Access Compliance Report

Public Rights-of-Way

(Curb Ramps)

Intersection ID: 10035098	Main Street: PROVIDENCE_RETREAT_LN	Cross Street: N/A	Location: E
ADA ID: AB8374DD88D5	Ramp Type: Perp	Initial Pass/Fail: Fail	Overall Compliance: No
Severity Score: 8.75			
Codes/Mitigation Info/Possible Solution		Field Measurements/Component Compliance

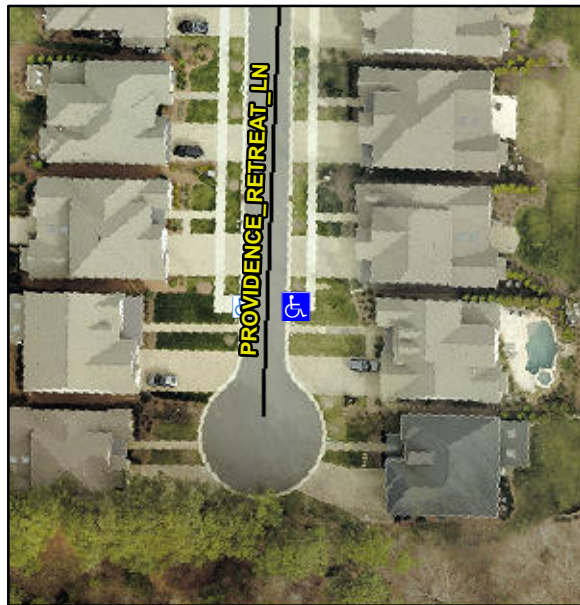
Not Found, R304.5.1

Compliance	Description	Data	Compliance	Description	Data
N/A	Ramp Length (in)	96.0	Yes	Ramp Slope (%)	5.1
No	Ramp Width (in)	47.0	Yes	Ramp XSlope (%)	1.4
N/A	Flare Type LT	N/A	N/A	Flare Type RT	N/A
N/A	Flare Slope LT (%)	N/A	N/A	Flare Slope RT (%)	N/A
N/A	Flare Traversable LT?	N/A	N/A	Flare Traversable RT?	N/A
N/A	Landing Length (in)	N/A	N/A	DWS Provided?	N/A
N/A	Landing Width (in)	N/A	N/A	DWS Contrast?	N/A
N/A	Landing Slope (%)	N/A	N/A	DWS Length (in)	N/A
N/A	Landing X Slope (%)	N/A	N/A	DWS Full Width?	N/A
N/A	Landing Curb? (Y/N)	N/A	N/A	DWS Offset (in)	N/A
N/A	Shared Landing?	N/A			
N/A	Gutter Ponding?	N/A	N/A	Gutter Slope (%)	N/A
N/A	Gutter Lip Ht (in)	N/A	N/A	Gutter X Slope (%)	N/A
N/A	Painted X Walk1?	No	N/A	Painted X Walk2?	N/A
	X Walk 1 Direction	To W		X Walk 2 Direction	N/A
N/A	X Walk 1 Width (in)	N/A	N/A	X Walk 2 Width (in)	N/A
	X Walk 1 Slope (%)	3.6		X Walk 2 Slope (%)	N/A
	X Walk 1 X Slope (%)	2.6		X Walk 2 X Slope (%)	N/A

Remove & Replace Entire Ramp.
